Delegated Report

Condition Discharge Application

Planning Application No:	20260469
Location:	Car Park Milton Place Gravesend Kent
Description:	Application for the approval of condition 12 (Elevations) and the partial approval of condition 14 (Swift Bricks) attached to planning reference number 20250167.
Applicant:	The Hill Group
Site Visit Date:	Desktop Assessment

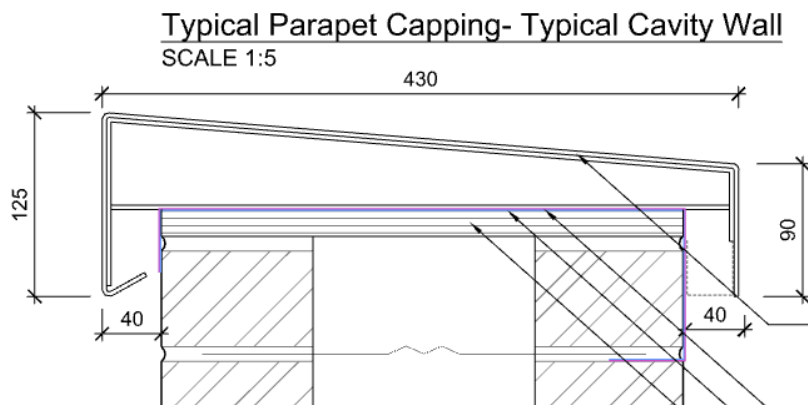
- *Single, committed specification for ED1 (apartment entry door) and ED5 (cycle/bin/plant room entry door) – the schedule currently offers “Steel or Aluminium/Timber Composite” for both. A condition cannot be discharged against an either/or specification. As seen in the attached updated ext materials schedule I sent on 29.06, the entrance door & ED5 door system was specified:*

It is also worth mentioning to the Conservation Officer that ED5 is not the cycle, bin or plant room door – it is the Staircore 1 entrance. The cycle / bin / plantroom is as follows:

System – AluK GT55TB Commercial Door AFT
Opening Direction – Outward
PAS24 – No
Finish – RAL 9005 Deep Black – Matt (Single Colour, Both Sides)
Handles – Silver Anodised PAD Handles
Main Lock – Euro Latch, Fail-Safe EStrike
Cylinder – Without Cylinders
Cill – Double Ramped Low Threshold & 3mm Aluminium Pressing Full Width Once Bent 90 Degrees – Mill Finish
Glass Type – 28mm Aluminium Glaze-in-louvre
